Council assessment of Clause 4.6 request

1 Visual representation of height offset

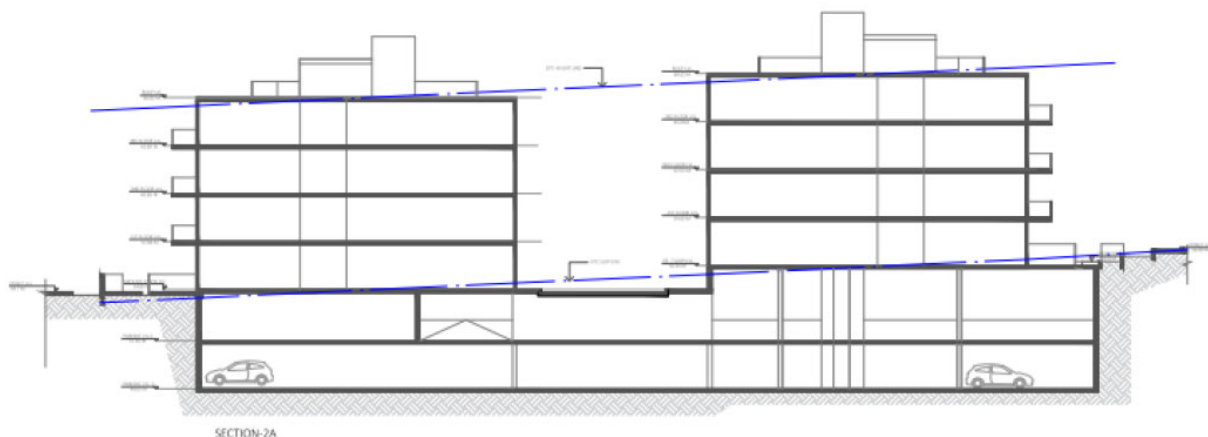
The following figure identifies the portions of the development that exceed the height limit and the portions of the development that are below the height limit. The roof areas coloured in white in the image below exceed the 12 m maximum building height permitted under Appendix 12 Blacktown Growth Centres Precinct Plan, State Environmental Planning Policy (Sydney Region Growth Centres) 2006.

The section plan below further illustrates the height non-compliance relating to the roof parapets of each proposed building based on the slope of the land, but will be offset with a greater proportion below the height plane, ie. parts of the buildings will be 1.1 m above the height plane while other parts will be 1.33 m below the height plane.
